ZS-2013-0194

Zion Nuclear Power Station, Units 1 and 2
Facility Operating License Nos. DPR-39 and DPR-48
NRC Docket Nos. 50-295 and 50-304

Subject: Updated Request for Amendment to Approve Methods of Analysis, use of the Upgraded Fuel Handling Building Crane System as a Single-Failure Proof Crane and Approval of a NUREG 0612 Compliant Heavy Loads Handling Program

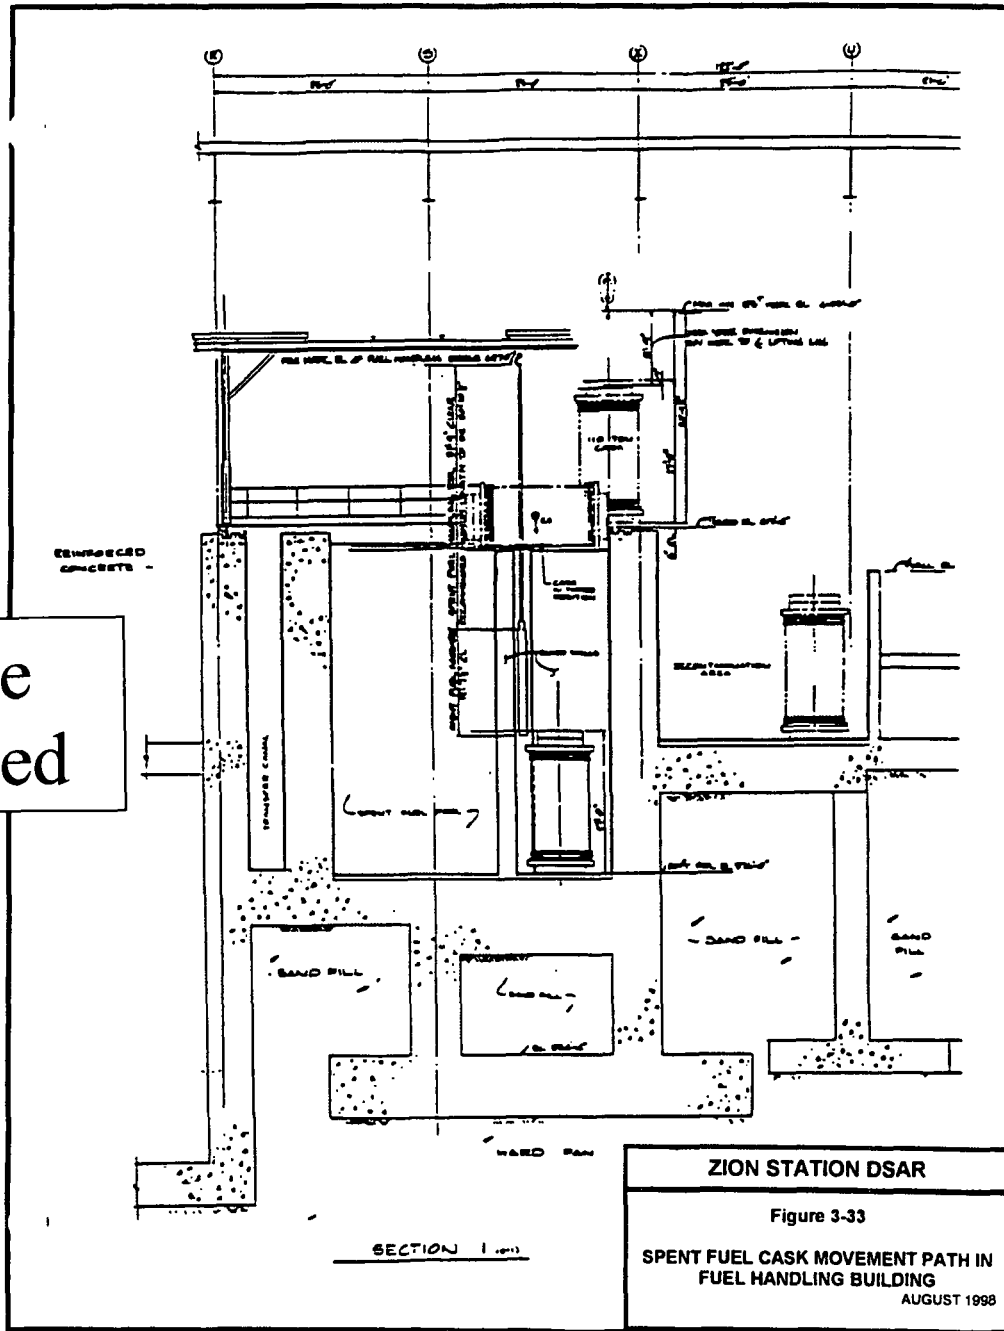
Figure
Deleted

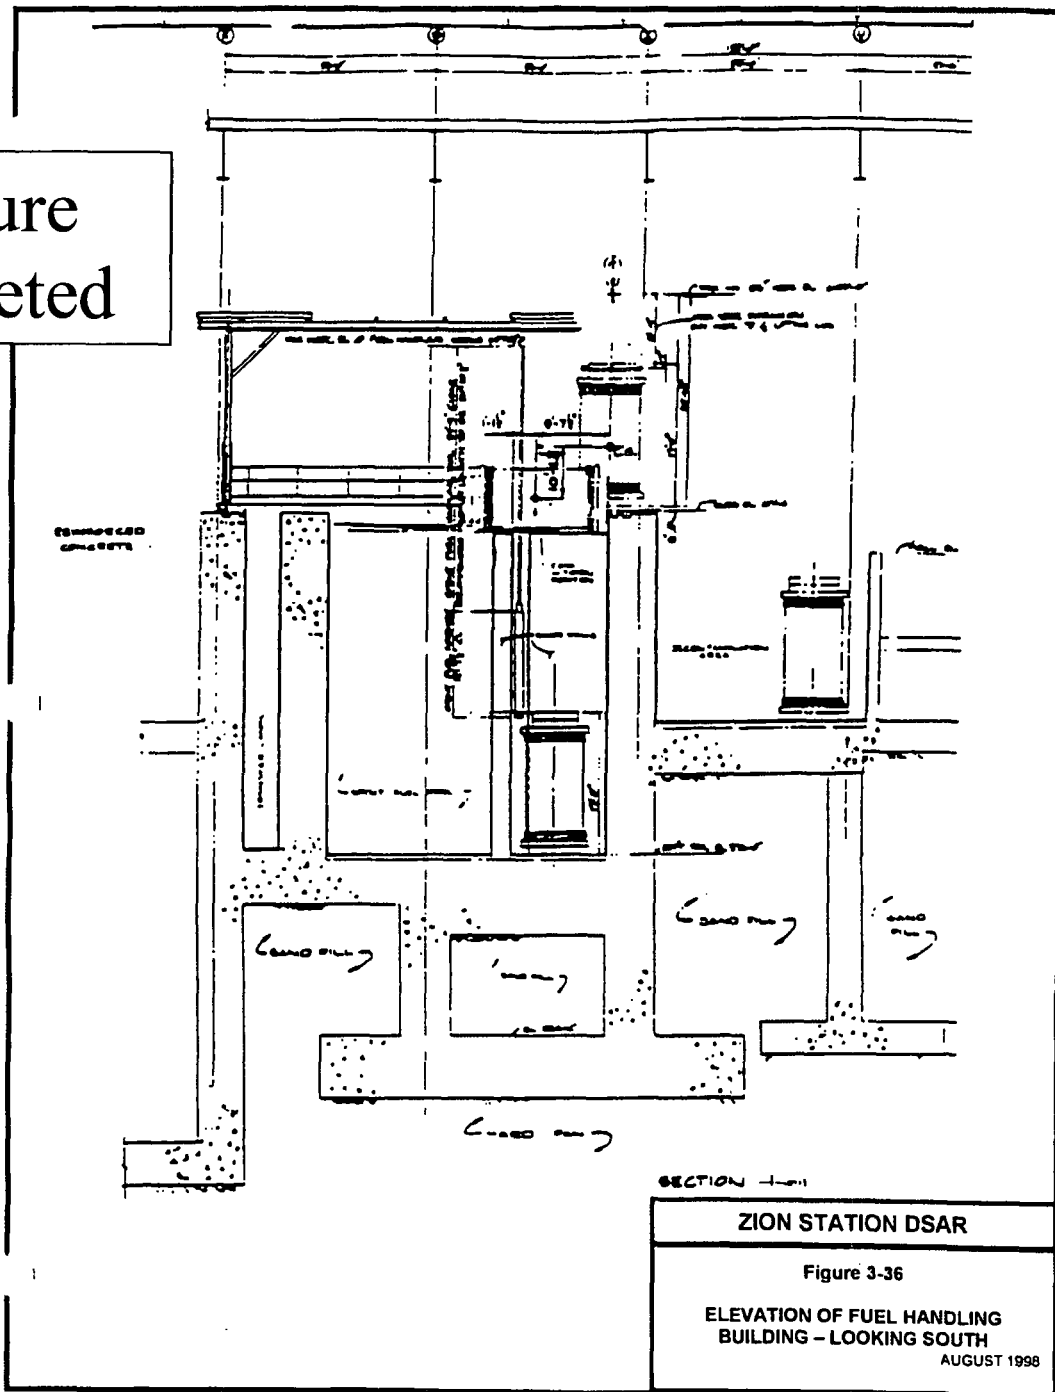
Figure
Deleted
